TOOLBOX M

500cc

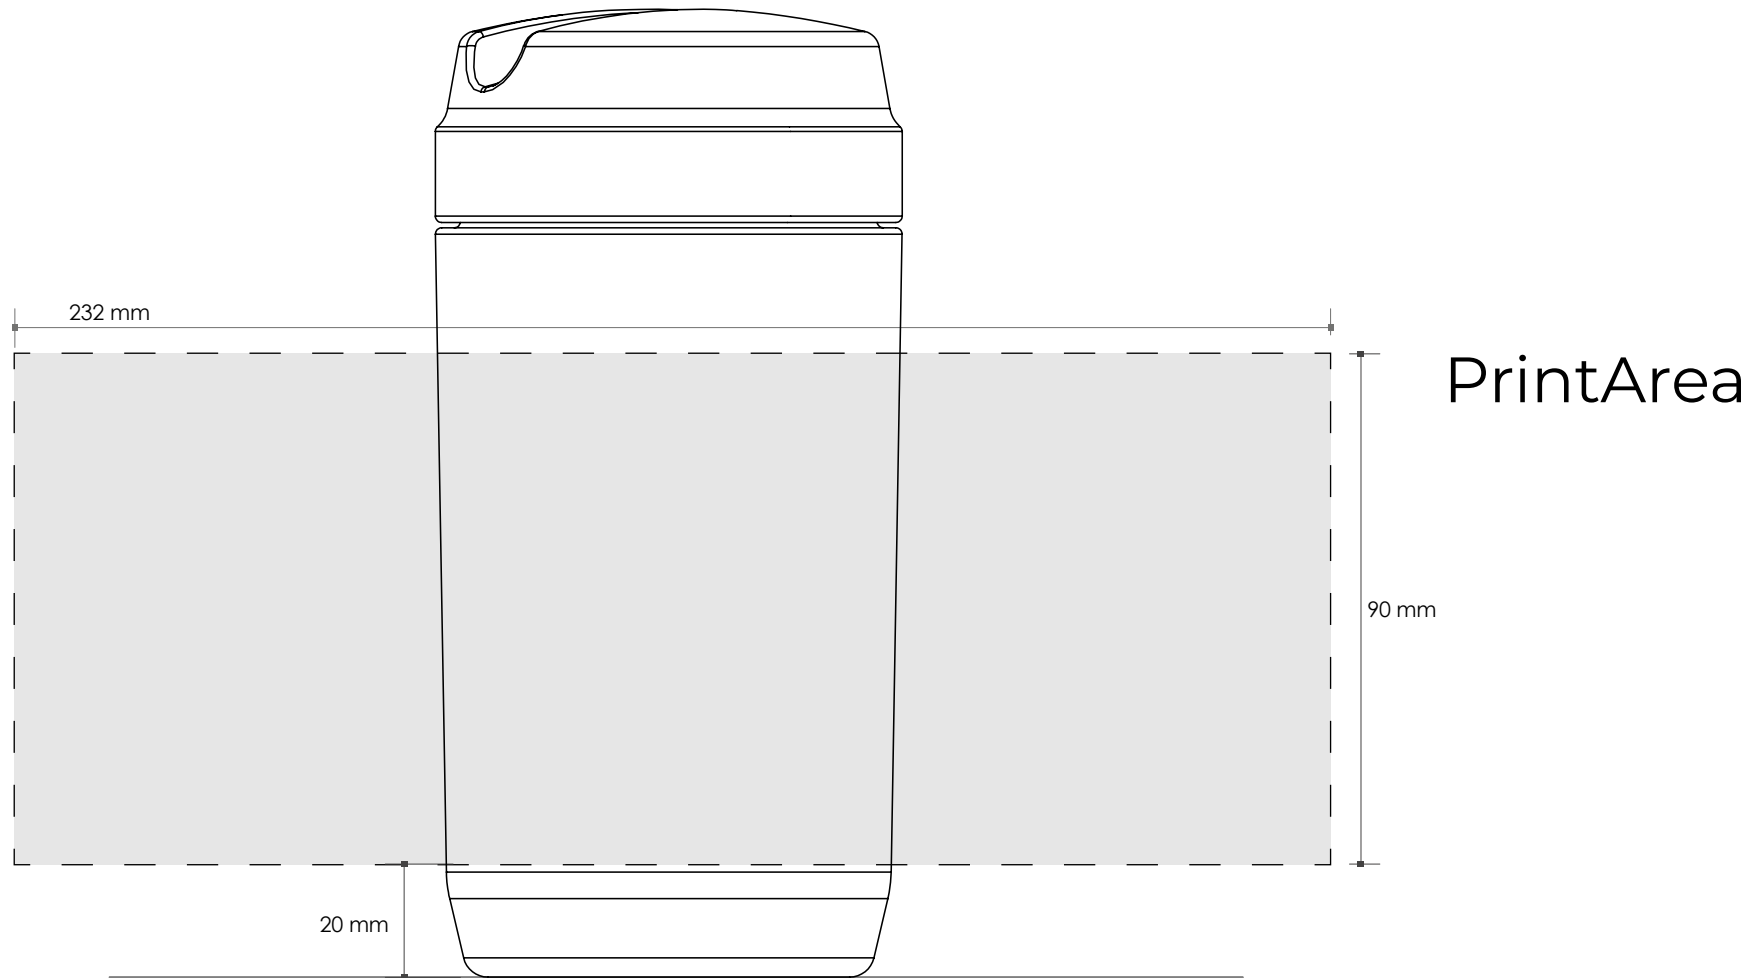
The impression can not close on the circumference of the bottle:
it's necessary to consider a non-printable area (approx. 0,8 cm width)
